**RE: Major Site & Subdivision Approval – Subdivision Amendment #5 Additional Items
Fairway View Village Development (Tax Map 32, Lot 13)
Fieldside Lane, Wells, Maine**

On behalf of York Building & Design Center, I have enclosed for your review and consideration additional materials in support of Subdivision Amendment #5 for the above-referenced project. This content covers the as-built stormwater infrastructure changes for a portion of the development that were constructed and briefly discussed as part of the Subdivision Amendment #4 application and approval but are being further detailed presently.

GRADING & UTILITY PLAN Pt.5
 FAIRWAY VIEW VILLAGE DEVELOPMENT
 FIELDSIDE LANE, WELLS, MAINE

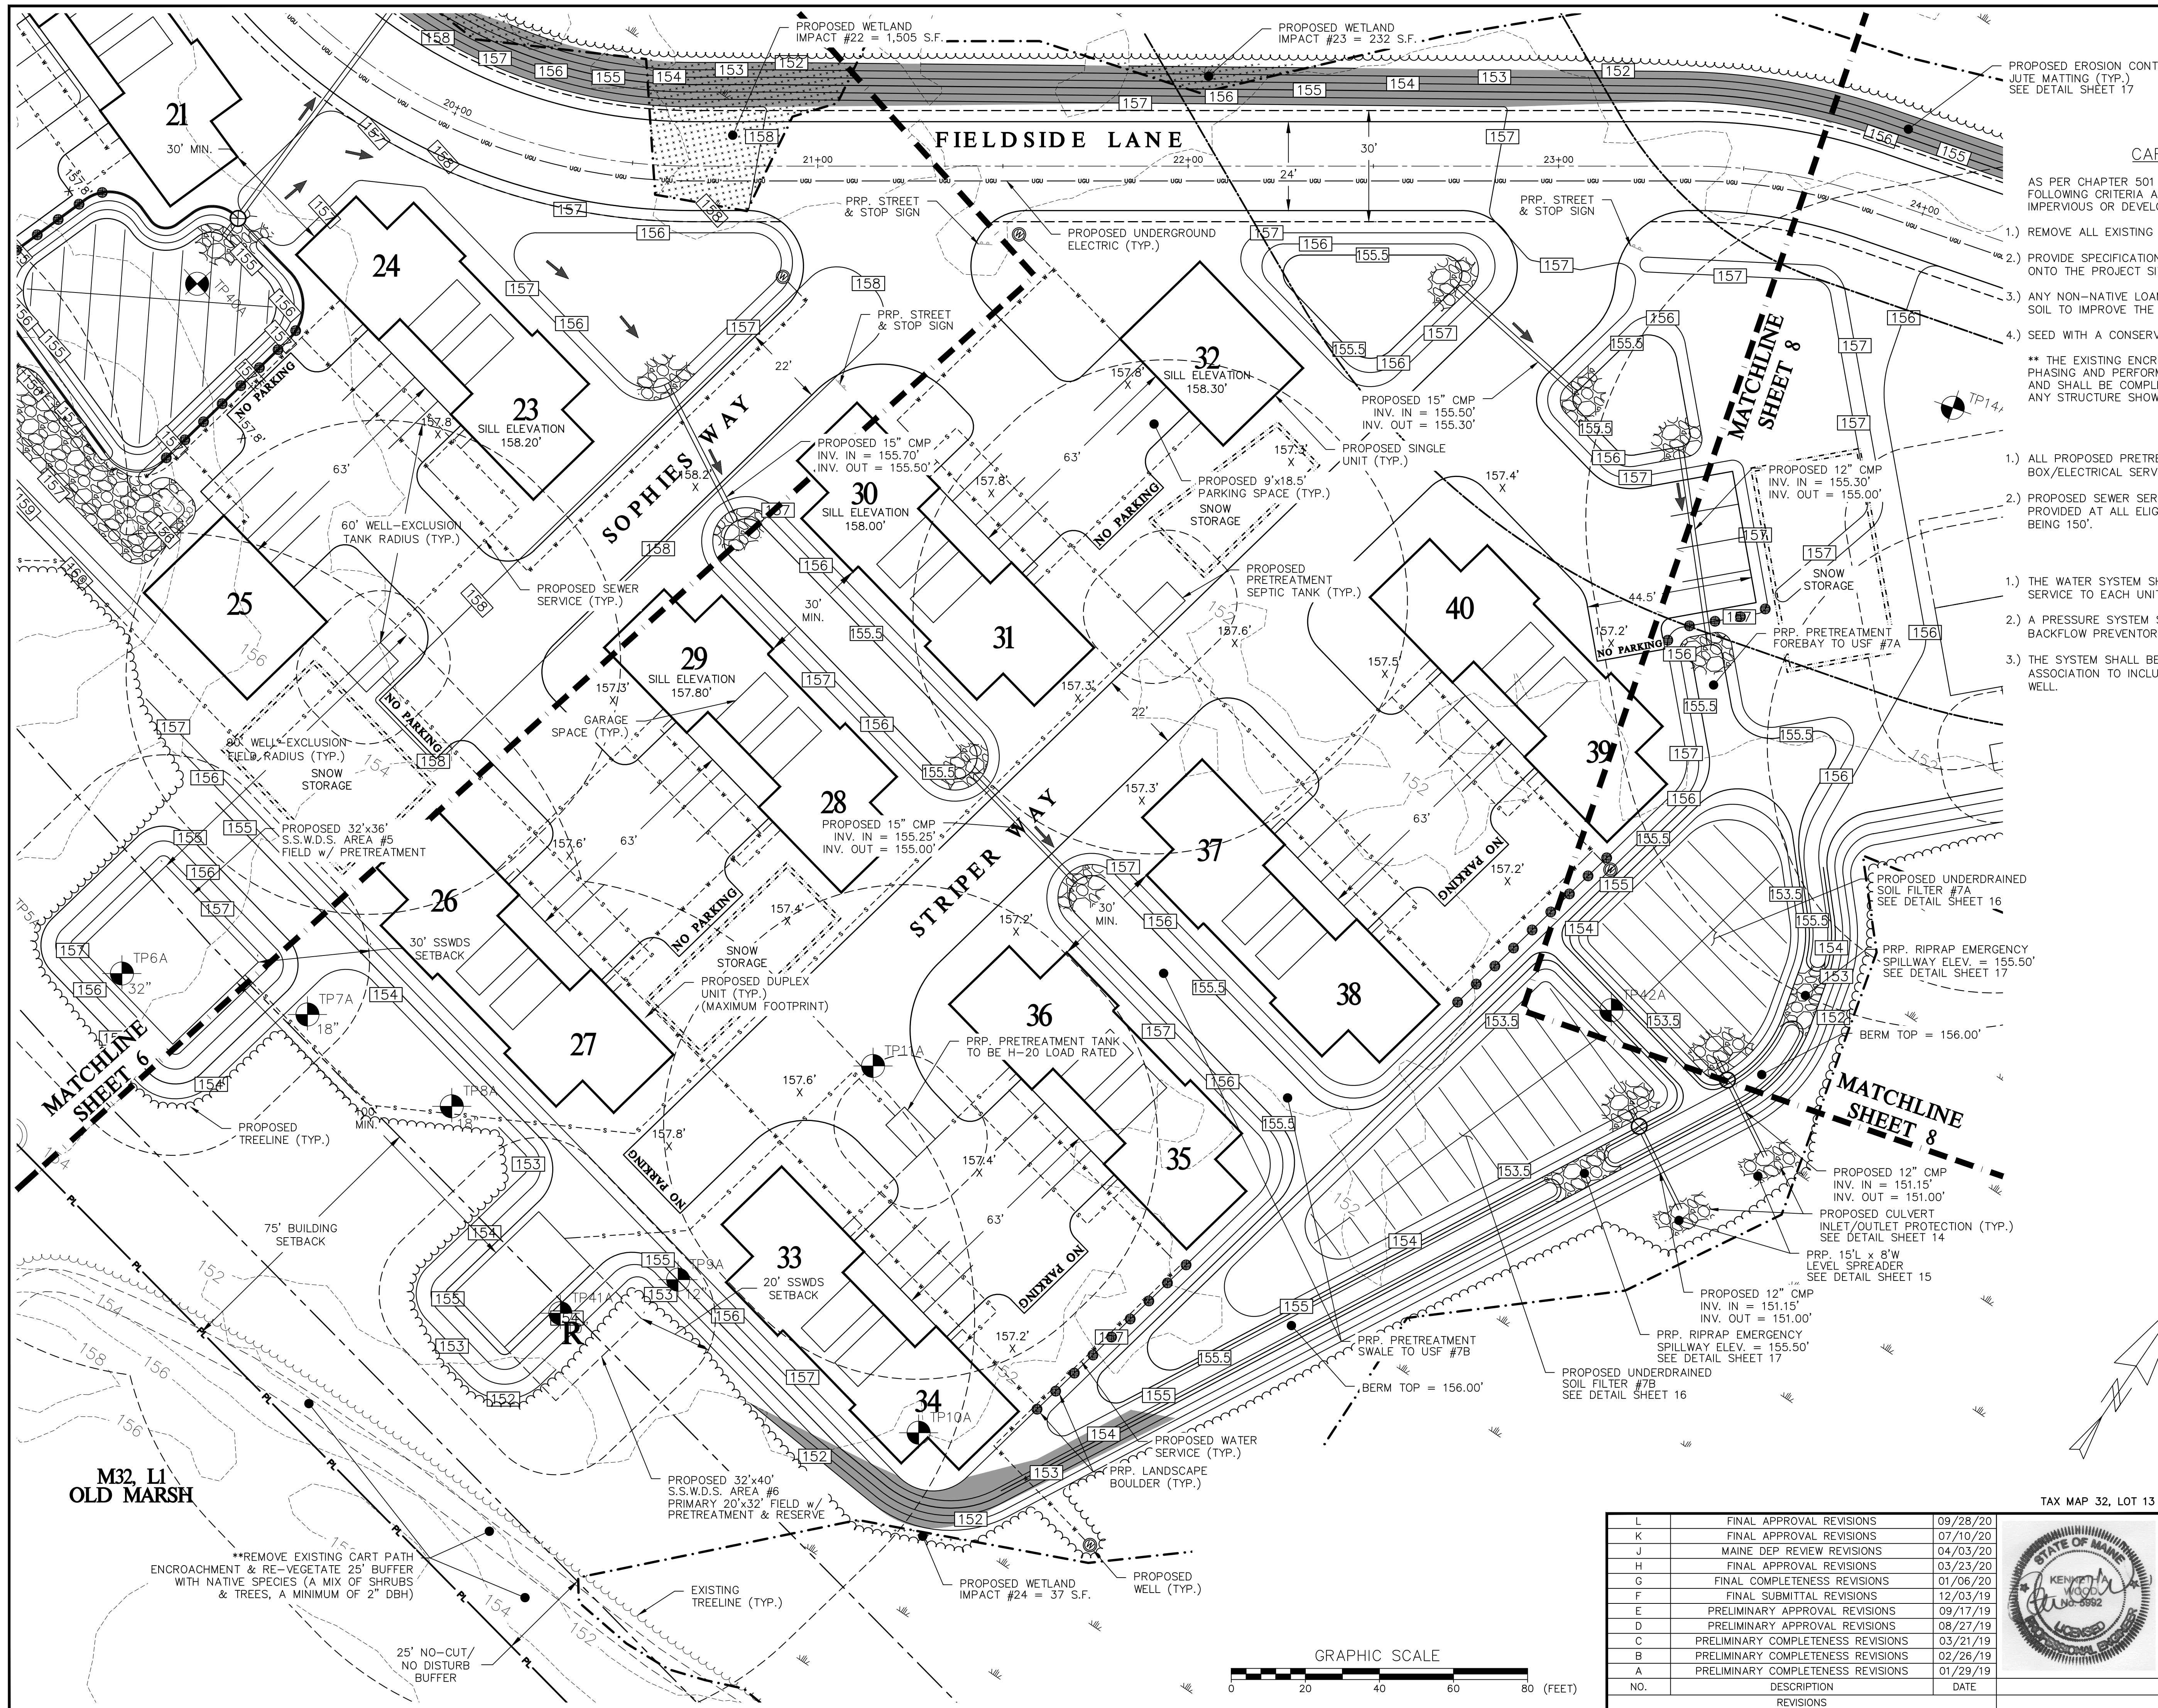
Grassed Underdrained Soil Filters #7A & #7B, located east of Striper Way, have had the following constructed changes relative to the design linework from the original approvals:

- GUSF #7A
 - Pond Node #19P (receiving Subcatchment 24S) has had its detention area significantly reduced
 - Pond Node #20P (receiving Subcatchment 25S) remains unchanged from the approved design, with the exception of a slightly longer outlet culverted crossing beneath the driveway of Units #32/46 to account for the loss of the GUSF forebay
 - Pond Node #21P (the GUSF itself) has had its forebay removed, but otherwise remains unchanged. Slight adjustments to surface area have been made but incremental storage volumes have been retained

- GUSF #7B
 - Pond Node #17P (receiving Subcatchment 22S) has had its detention area removed and replaced with a field inlet that receives runoff from this subcatchment and routes it to the GUSF
 - Pond Node #18P (receiving Subcatchment 23S) has had its detention area removed and replaced with a field inlet that receives runoff from this subcatchment and routes it to the GUSF
 - Pond #22P (the GUSF itself) has been slightly oversized relative to the approved design to accommodate for the loss of upstream incremental storage areas

An updated HydroCAD Report publish is attached to this cover letter along with the comparison spreadsheet that was submitted with the other SDV Amend #5 materials on March 19th 2026. Additionally, the Grading & Utilities Plan for this portion of Phase II of the development from the original approvals is also attached to further speak to the revisions described above.
